CX4 proposed Tx Template Issues

Ze'ev Roth, Dimitry Taich

Zoom In on Initial Rise

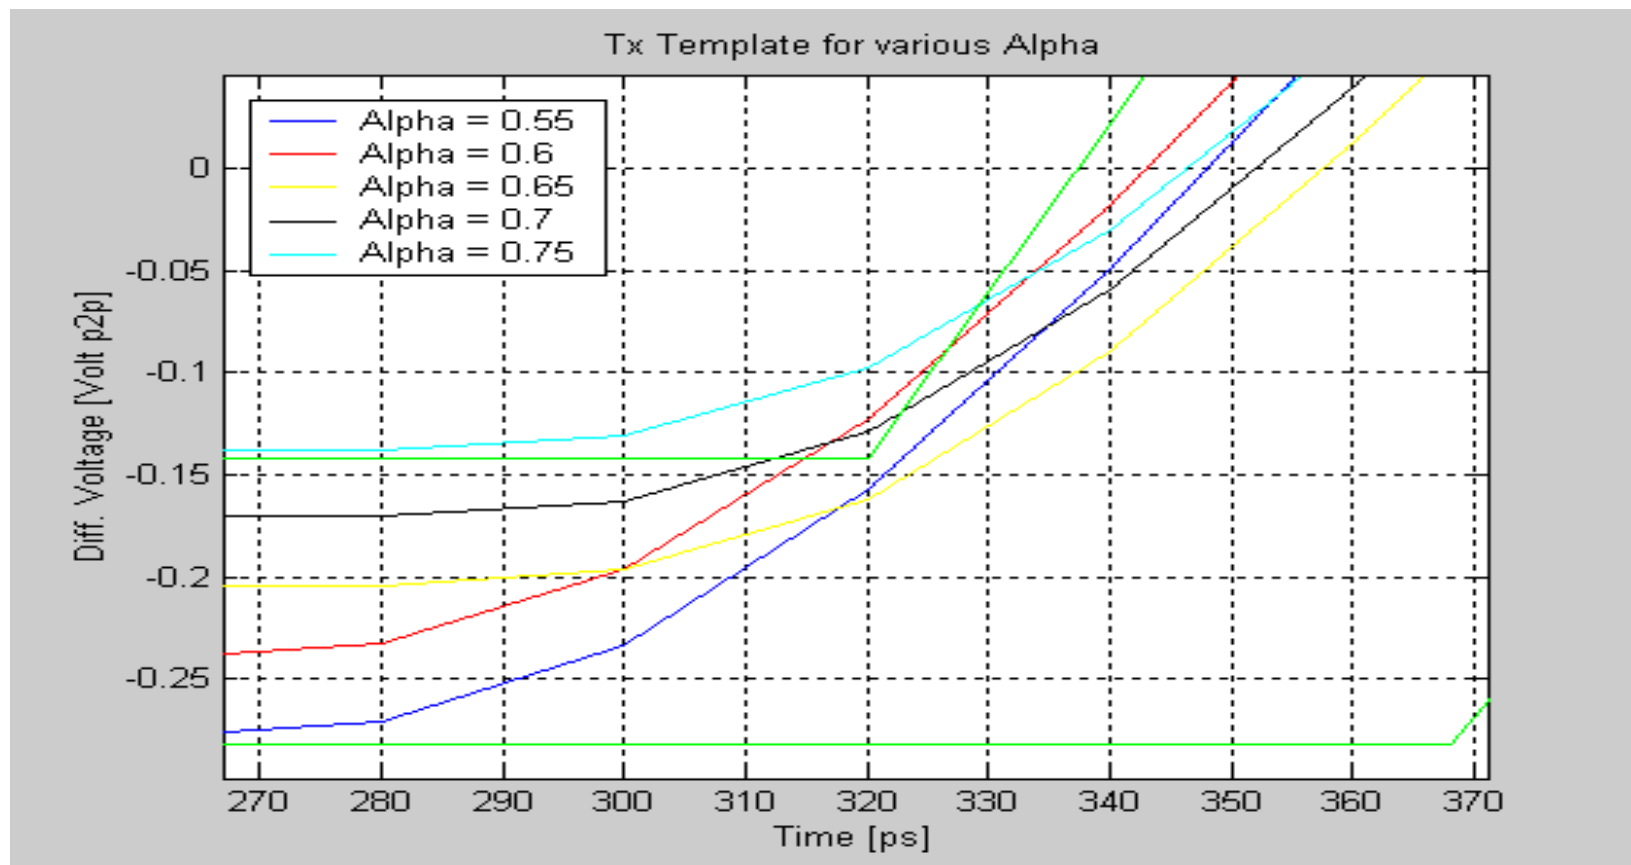
Only nominal (Alpha= 0.65) and Alpha=0.55 conform

Zoom In on Positive Peak

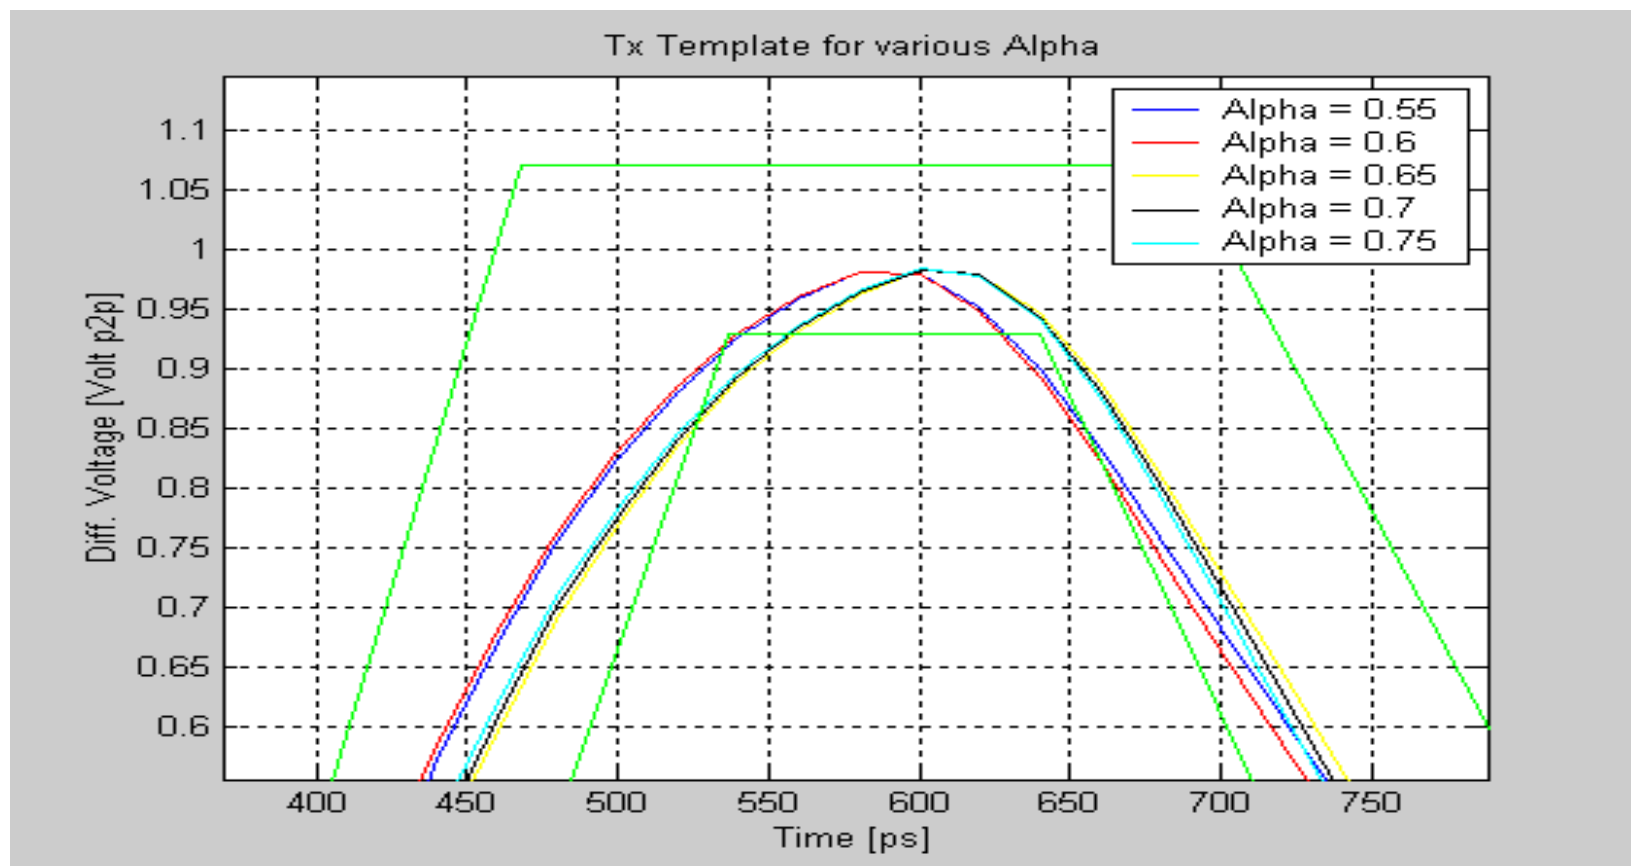
None of the values conform including the nominal 0.65

Zoom In on Positive Steady State

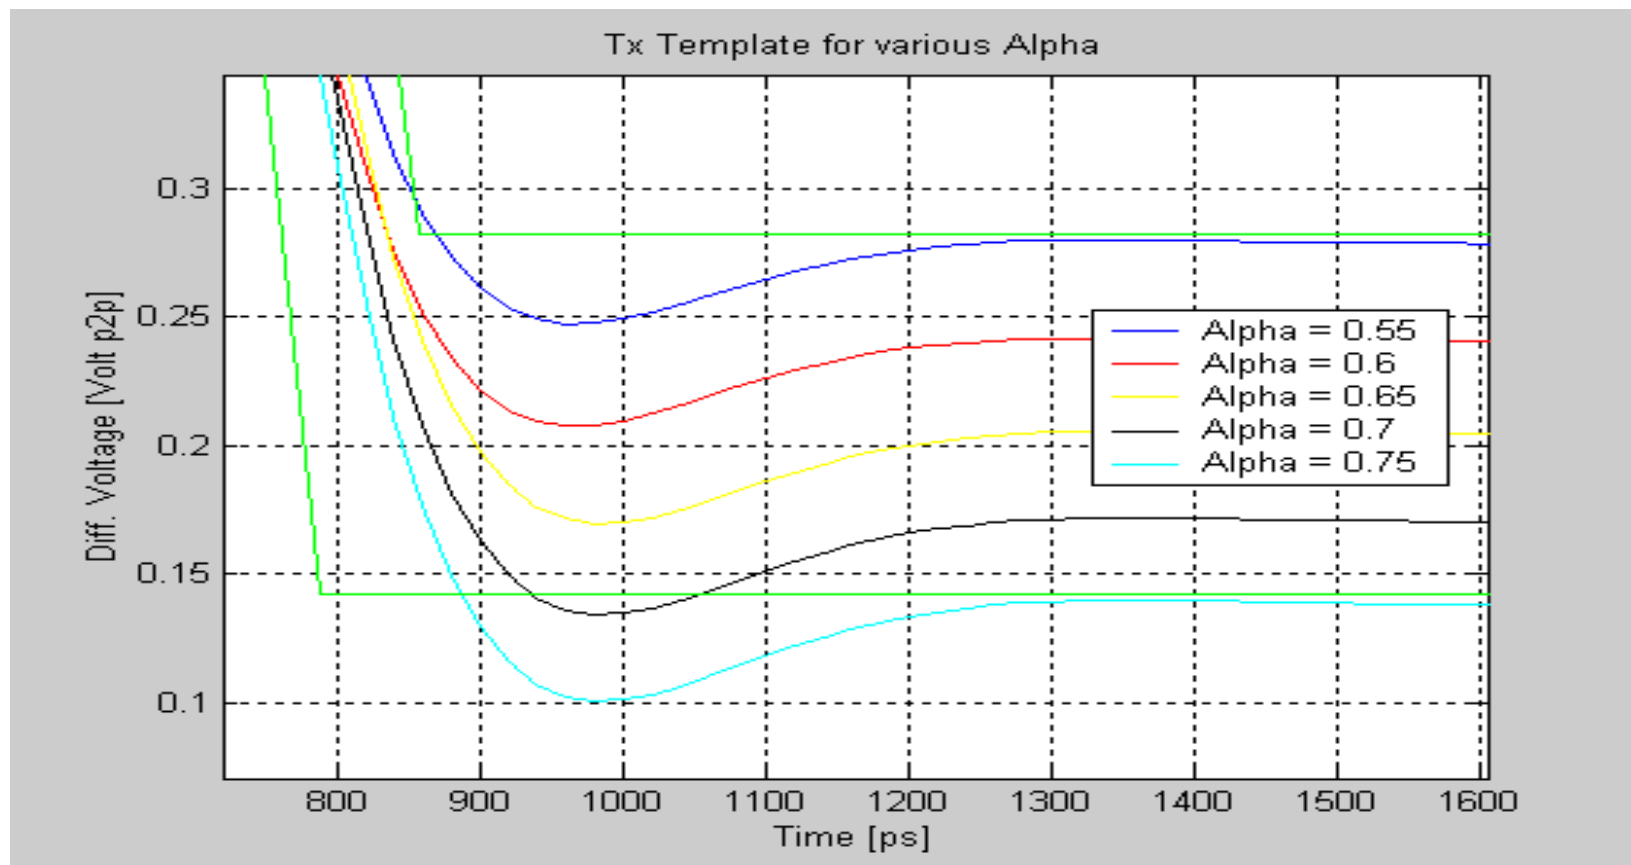
Only nominal (Alpha= 0.65) and Alpha=0.6 conform

Zoom In on Fall

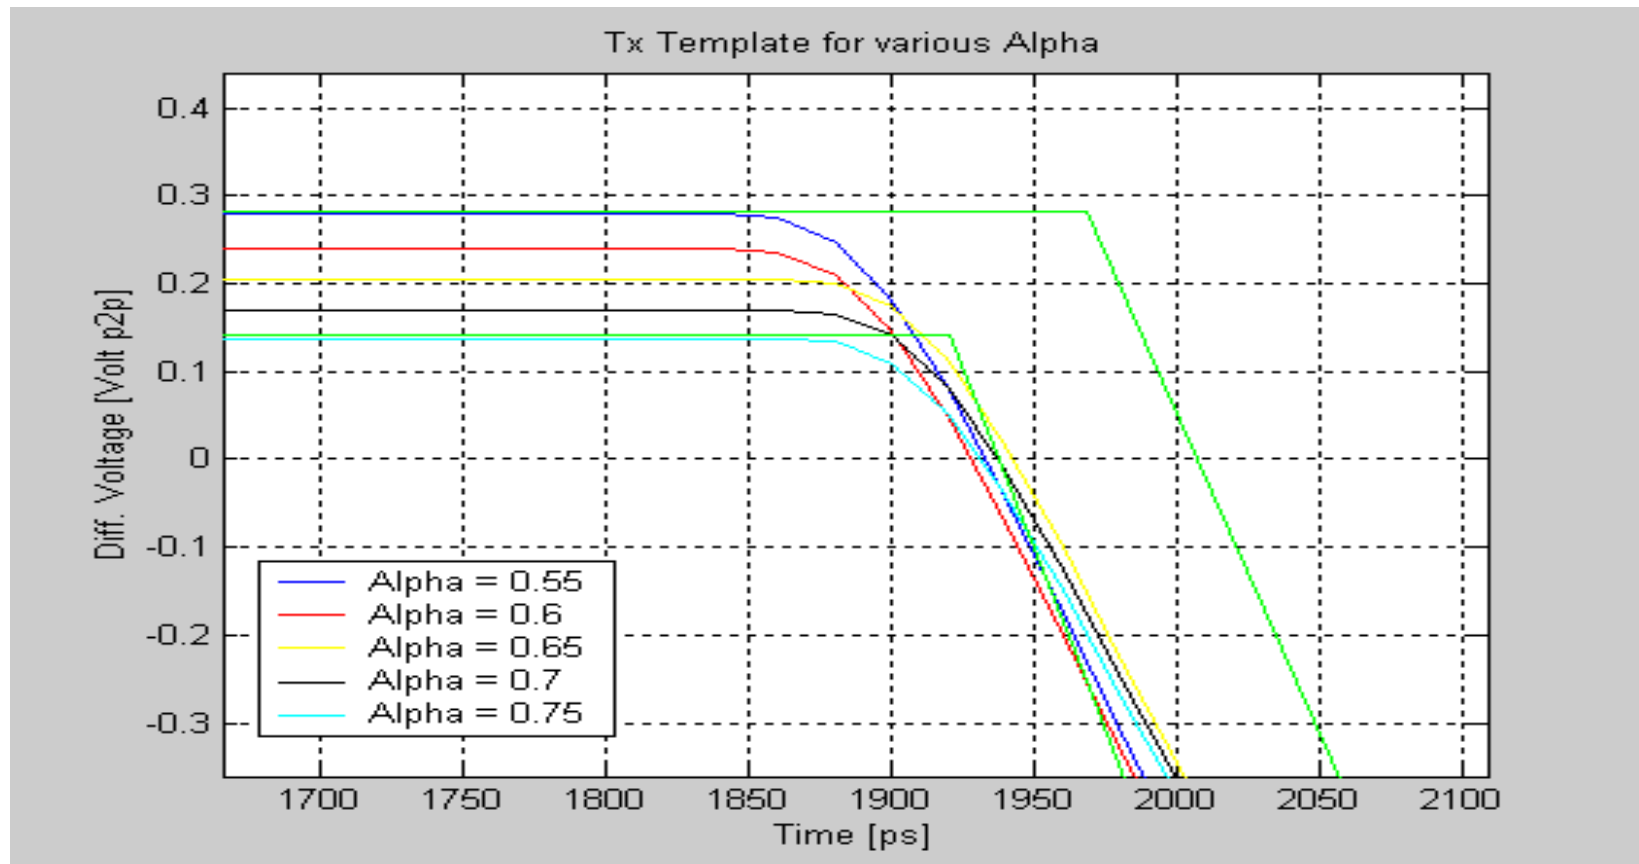
None of the values conform including the nominal 0.65

- This template is not consistent
 - Even nominal value or pre-emphasis doesn't conform
- Template needs to be revised to accommodate:
 - Variations in Alpha
 - Variability of Tx LPF
 - Tx Jitter
- Perhaps rather than specifying the pre_emphasis at TX output directly we should aim to measure it indirectly at end of compliant channel
